Information Bulletin

| Reference No. : | GSM04072025-KK |

Notice of relating to the label “PSE” according to the part of revision for Electrical Appliances and Materials Safety Act.

PFBR-150SW-MN

| The current nameplate (with PSE label) | The nameplate after changed (without PSE label) |

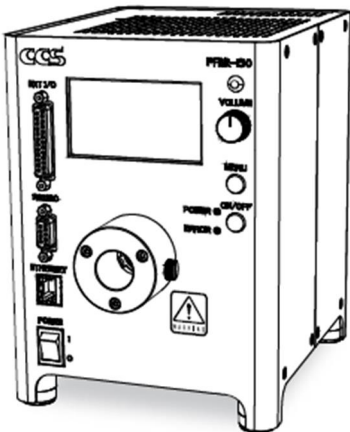
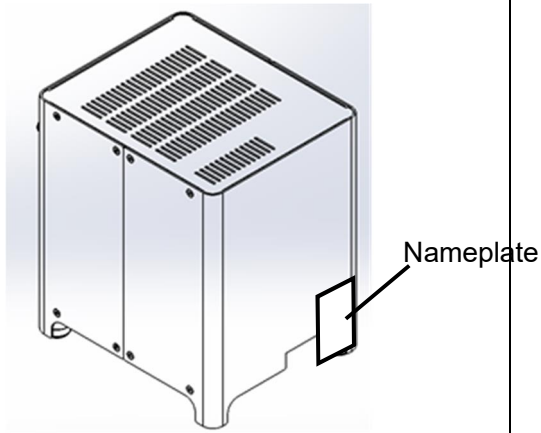
PSE label  will be removed from the nameplate and the instruction manual.

| The current nameplate (with PSE label) | The nameplate after changed (without PSE label) |
|---|--|
|  <p>MODEL PFBR-150 INPUT 100-240V~170VA INPUT Freq. 50/60Hz OUTPUT S/N MAC ADDRESS Manufacturer: CCS Inc. 374 Okakuencho, Kamigyo-ku, Kyoto 802-8011, JAPAN</p> <p>EU Importer: CCS Europe N. V. Bergensesteenweg 421B, 1800 Sint-Pieters-Leeuw, Belgium UK Importer: Gardasoft Vision Ltd. Trinity Court, Buckingham- Business Park, Swavesey, Cambridge, CB24 4UQ, UK</p> <p>CE UKCA 10</p> <p>INPUT:AC100V 50/60Hz 150W</p> <p>PS E レボックス株式会社</p> |  <p>MODEL PFBR-150 INPUT 100-240V~170VA INPUT Freq. 50/60Hz OUTPUT S/N MAC ADDRESS Manufacturer: CCS Inc. 374 Okakuencho, Kamigyo-ku, Kyoto 802-8011, JAPAN</p> <p>EU Importer: CCS Europe N. V. Bergensesteenweg 421B, 1800 Sint-Pieters-Leeuw, Belgium UK Importer: Gardasoft Vision Ltd. Trinity Court, Buckingham- Business Park, Swavesey, Cambridge, CB24 4UQ, UK</p> <p>CE UKCA 10</p> <p>Removed the PSE label</p> |
